**Meeting Agenda
Plat Committee**

Monday, September 13, 2021

1. [KPB-3510](#) Pipers Haven Unit 3 2021 Replat; KPB File 2021-115

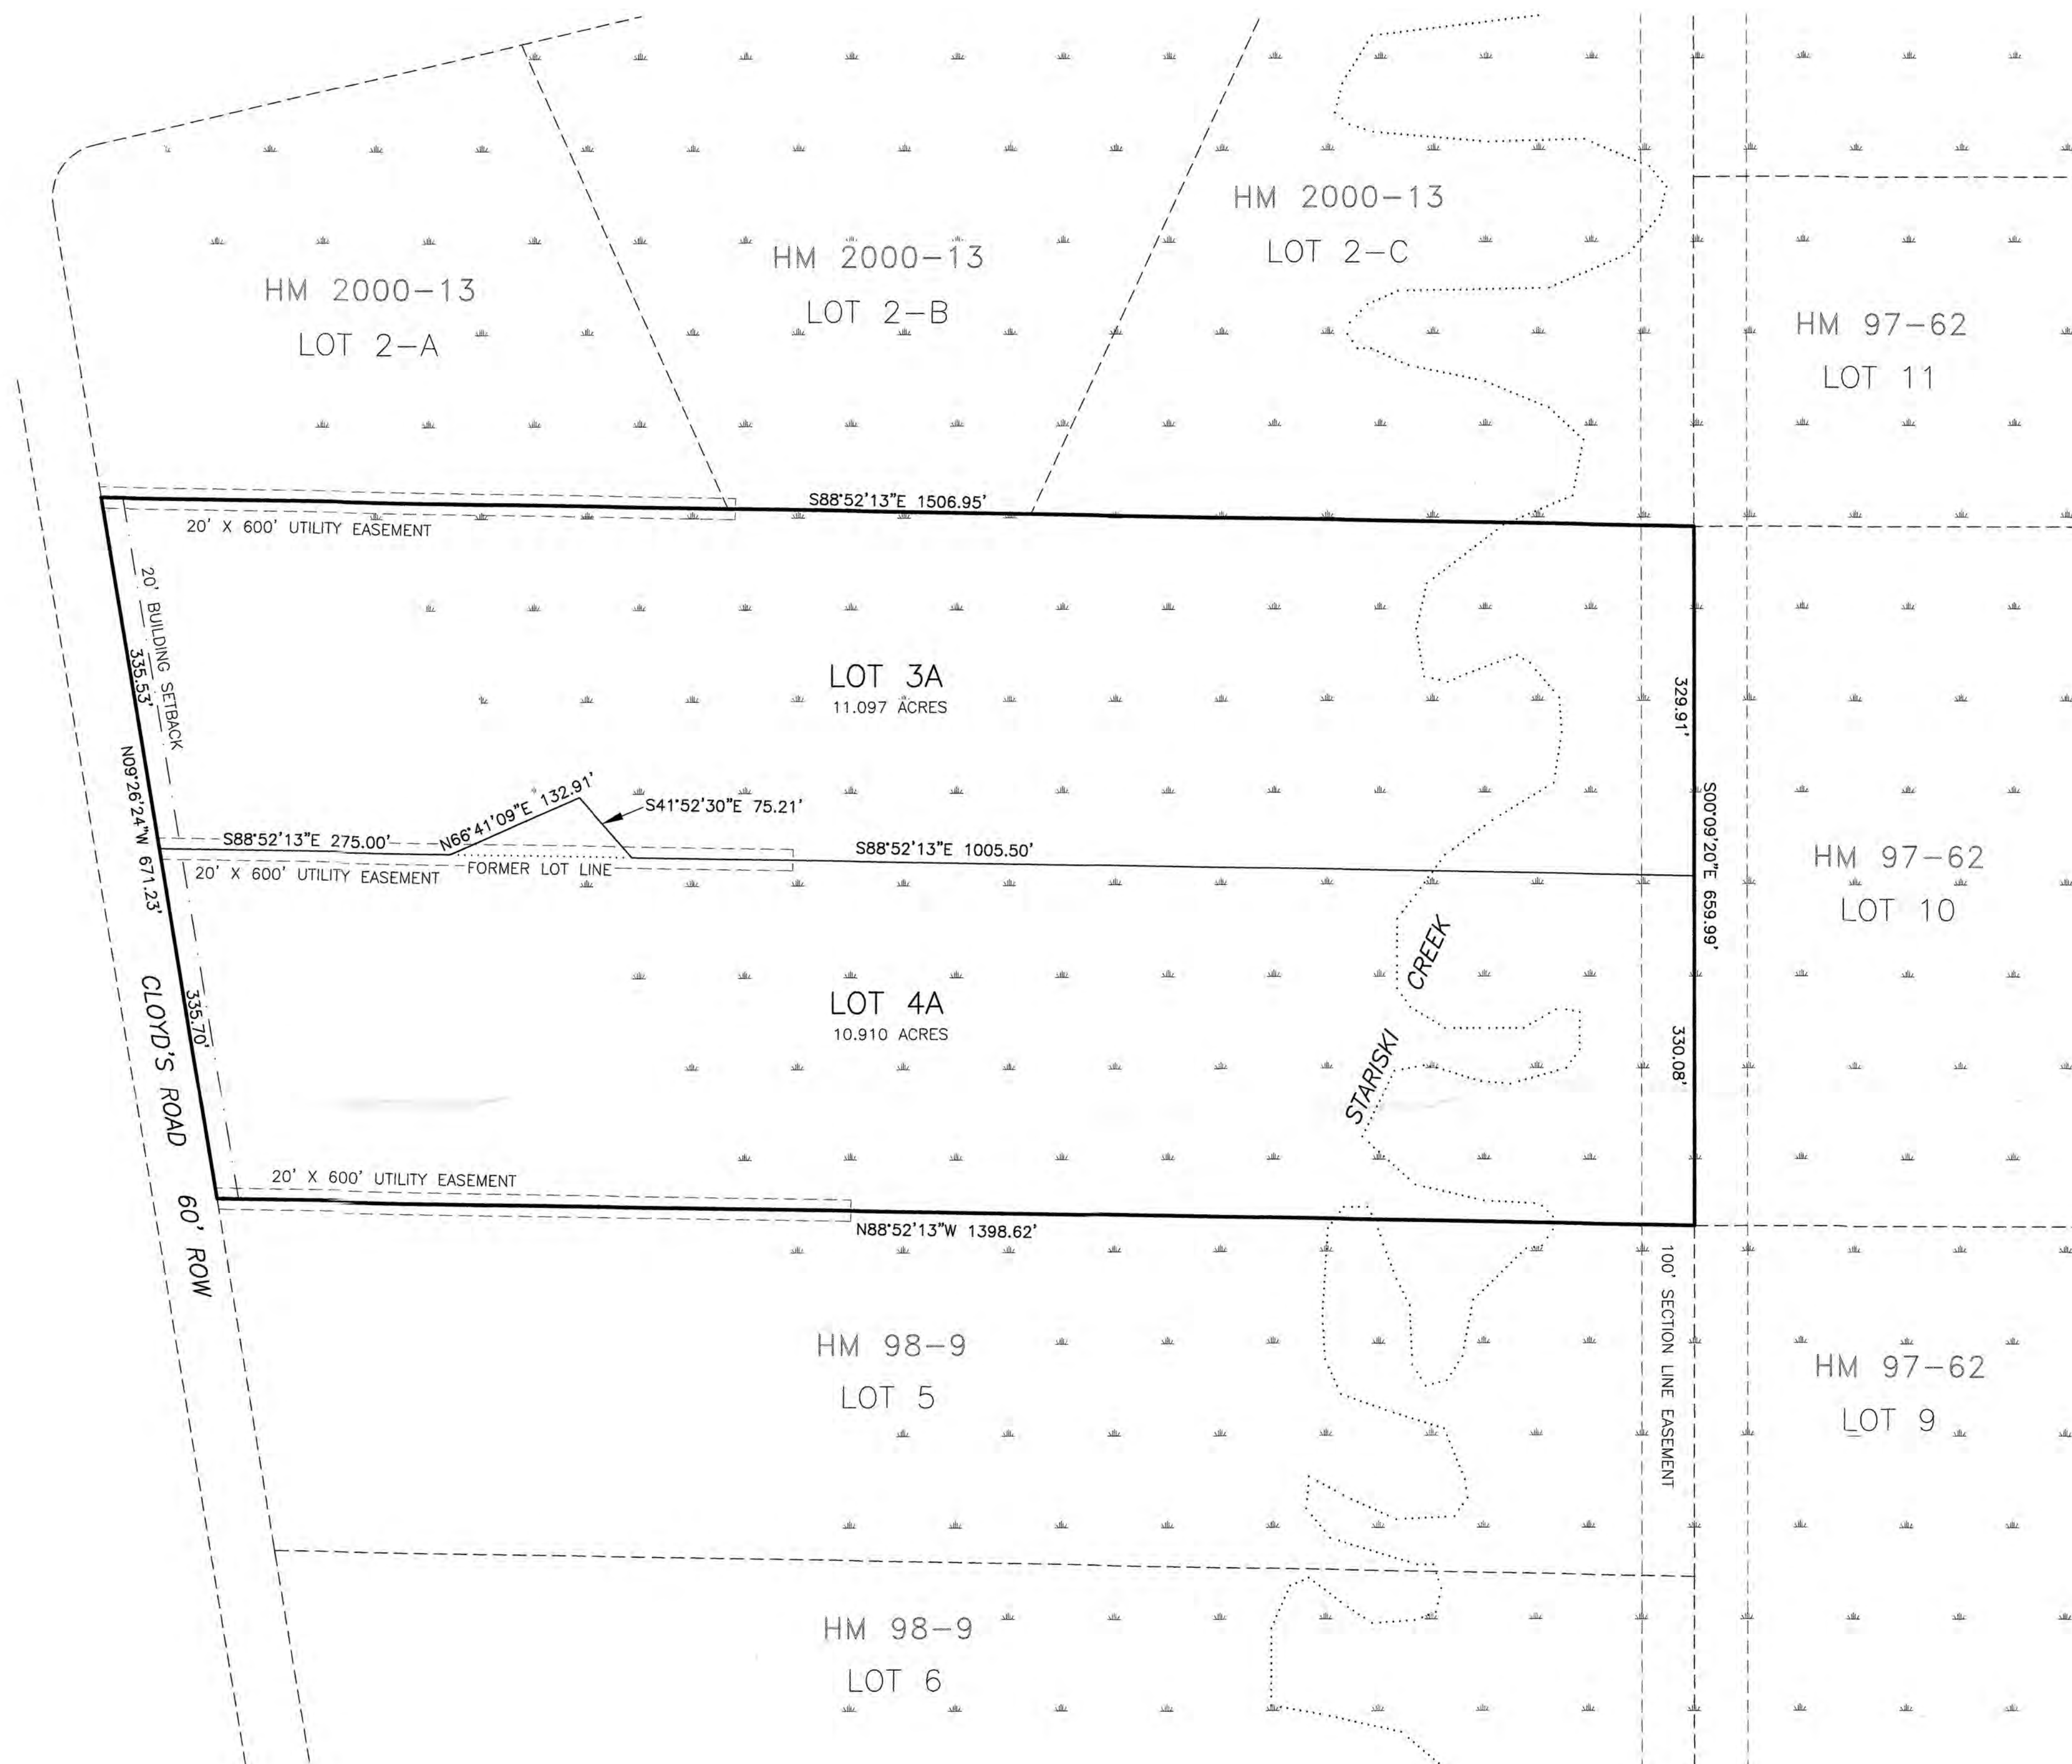
Staff recommends carry over the parent plat note regarding the natural meander boundary, site source for meander information on the plat, depict low wet areas and add a plat note "Any person developing the property is responsible for obtaining all required local, state, and federal permits, including a U.S. Army Corps of Engineers wetland determination if applicable."

- J. Block and lot numbering per KPB 20.60.140, approximate dimensions and total numbers of proposed lots;
Staff recommendation: Add a block label within Lot 22A.

Staff recommendation: *Revise the wording in the plat note to read "An Engineer's Subdivision and Soils Report is not available for this subdivision..." Comply with 20.40.*

Staff recommendation: *Provide meander information and source. Note if bearing and distances are from record or computed. If from record, the record must be disclosed. Comply with 20.60.110.*

Correct the following plat notes.

- Note 2, remove the "c" at the end of the sentence.

Surveyor Segesser Surveys 30485 Rosland St. Soldotna, AK 99669 (907) 262-3909	Owner RCMS Inc P.O. Box 1290 Kenai, Alaska 99611
JOB NO. 21029	DRAWN: 5-3-21
SURVEYED:	SCALE: 1"=100'
FIELD BOOK:	SHEET: 1 of 1

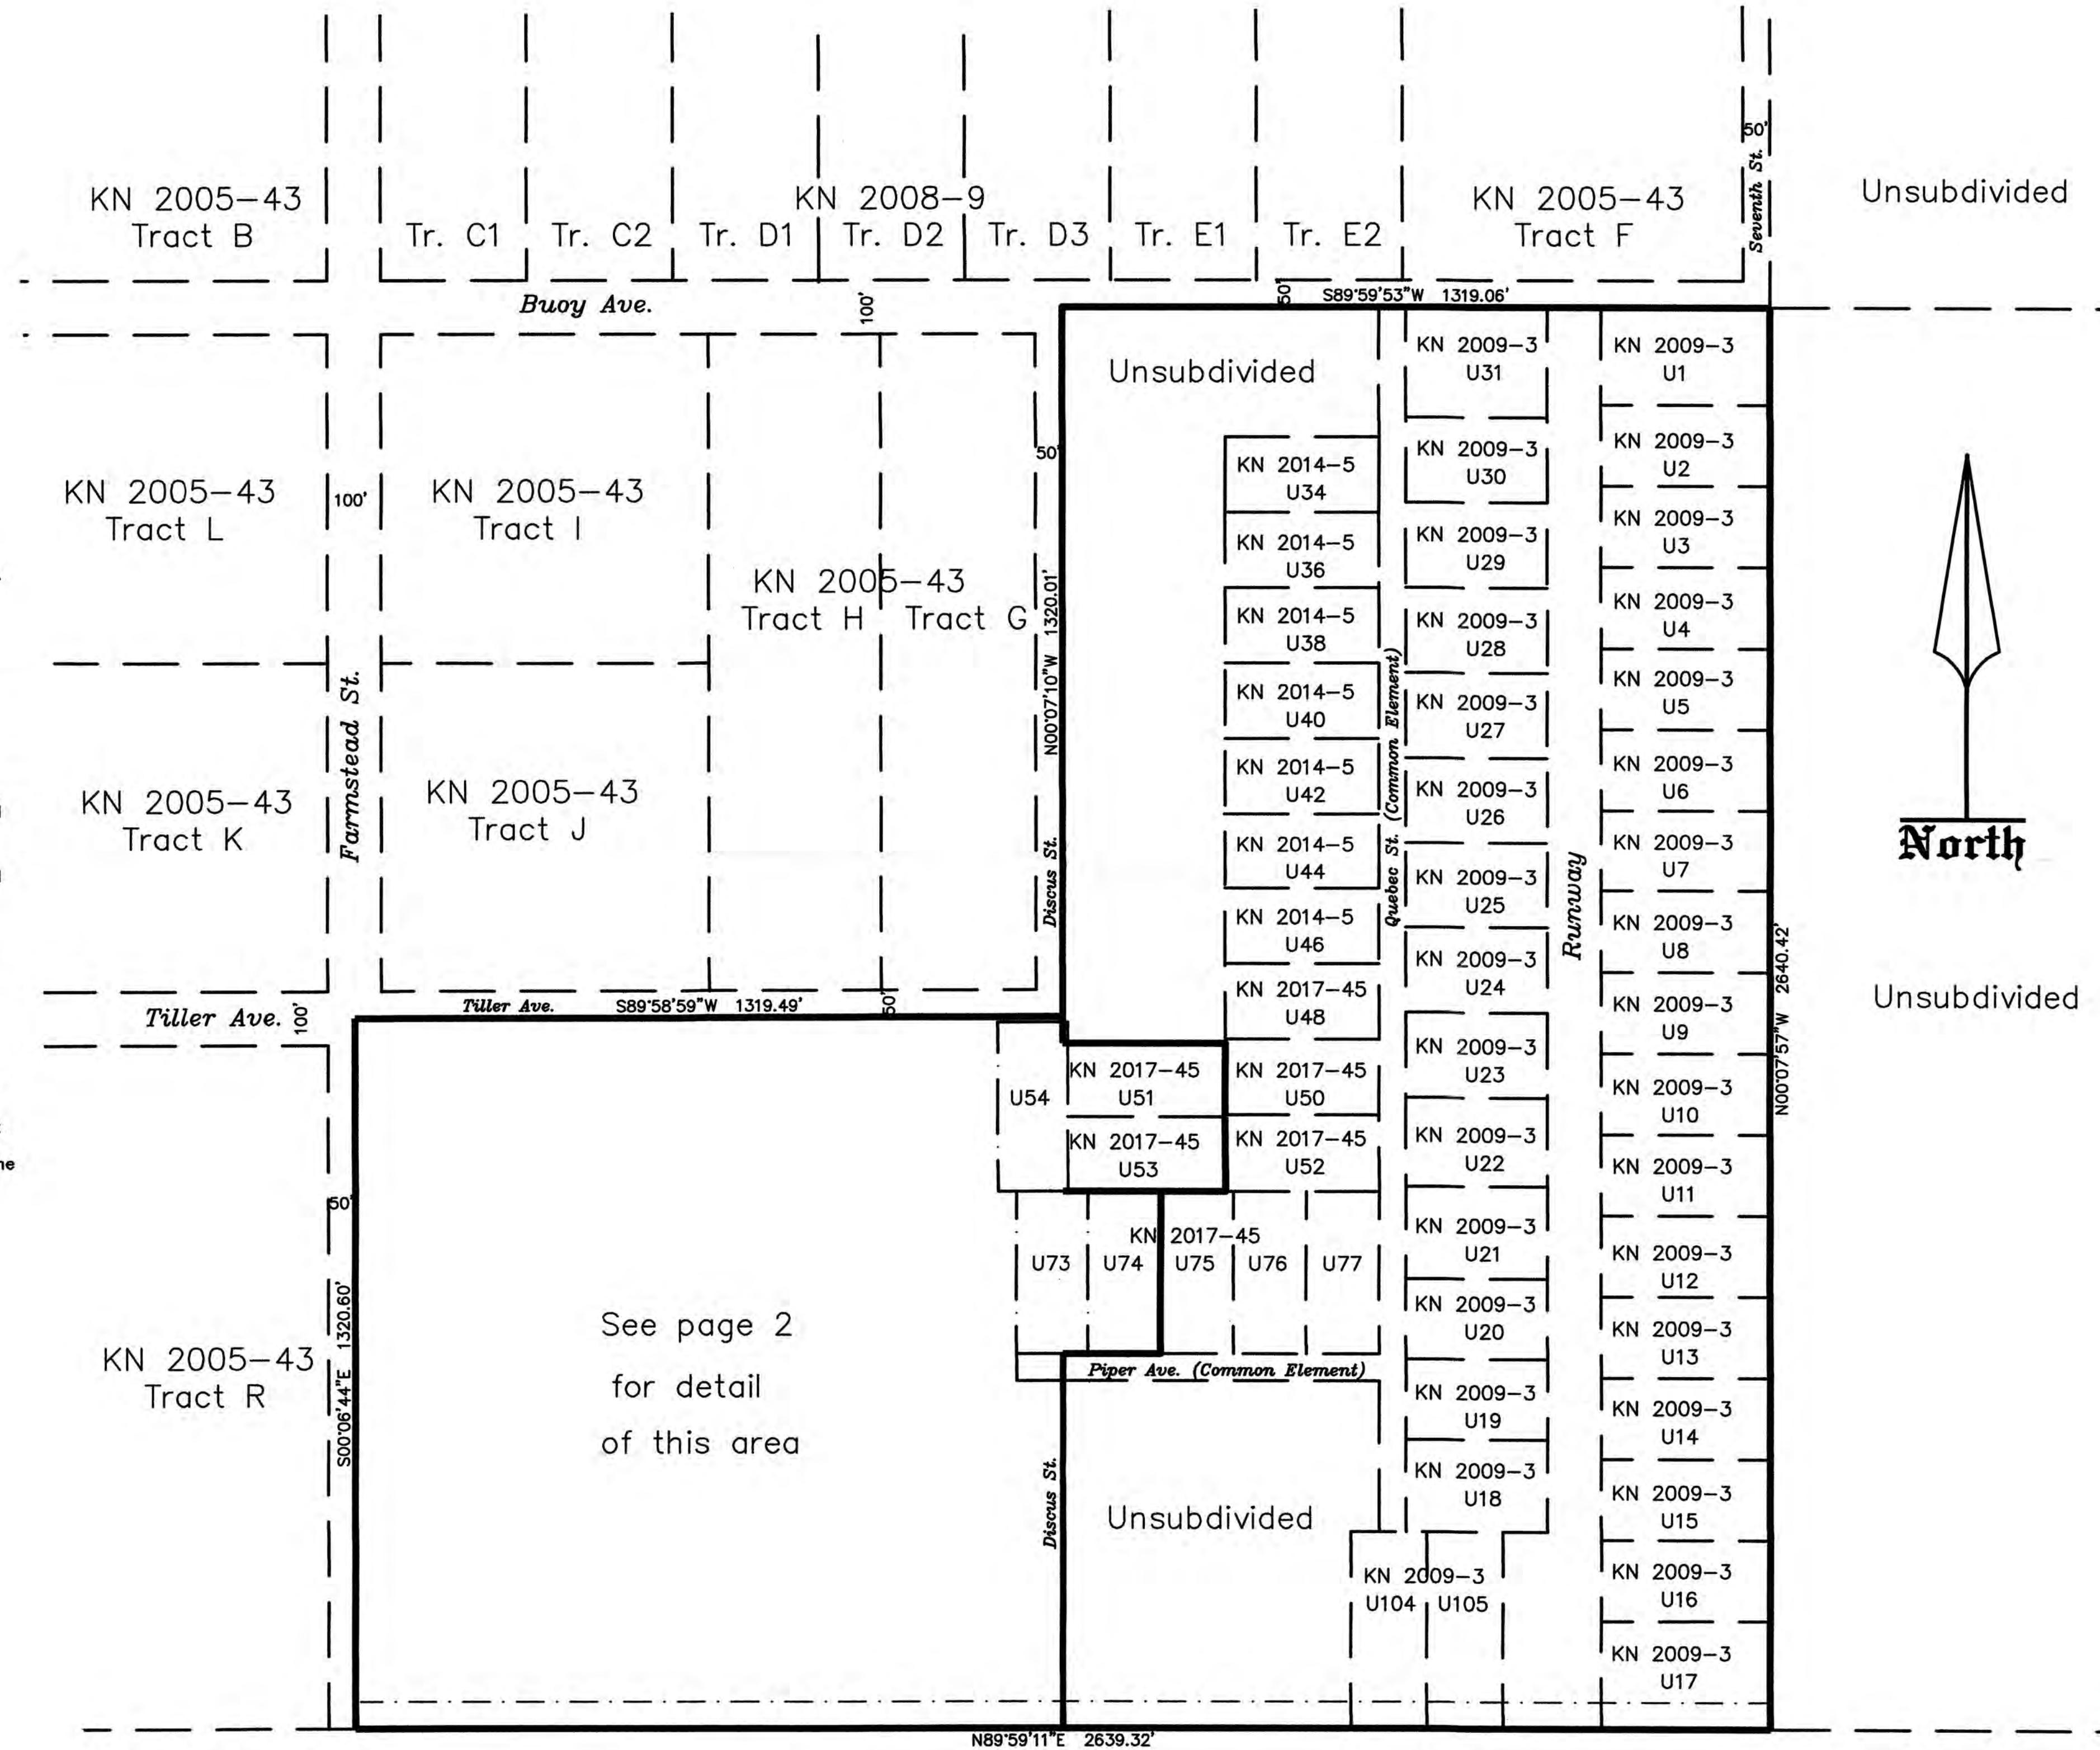
Tiller Avenue and Farmstead Street are currently 50 foot wide dedications. Sheet 2 indicates that 10 foot dedications are proposed and a 30 foot dedication along the south that coincides with a 50 foot section line easement (Image B).

A 60 foot wide dedication is proposed to provide a continuation of Discus Street. The design proposed shows a 10 foot offset from the northern dedication. This appears to be occurring due to unit locations. As discussed previously, this plat cannot change any unit design. **Staff recommends the right of way dedication for Discus Street be 60 feet wide and align with the current dedication of Discus Street.** (Image B).

- *Update the total subdivision acreage to 120 acres.*
 - *Update the pages accordingly to "Sheet 1 of 2" and "Sheet 2 of 2."*
 - *The scale for page 1 should be updated.*

- Staff recommendation:** *On sheet 1, depict and label the section line easements along the eastern and southern boundary.*
- G. The status of adjacent lands within 100 feet of the proposed subdivision boundary or the land status across from any dedicated rights-of-way that adjoin the propose subdivision boundary, including names of subdivisions, lot lines, block numbers, lot numbers, rights-of-way; or an indication that the adjacent land is not subdivided;

- Staff recommendation:** *On sheet 1, correct Tract B in the northwest corner as it has been replatted. Tract B1 of KN 2007-76.*
- H. Approximate locations of low wet areas, areas subject to inundation, areas subject to flooding or storm water overflow, and the line of ordinary high water. This information may be provided on an additional sheet if showing these areas causes the preliminary plat to appear cluttered and/or difficult to read;

Staff recommendation: *On sheet 1 update the boundary to show be the exterior of the 120 acre parcel.*
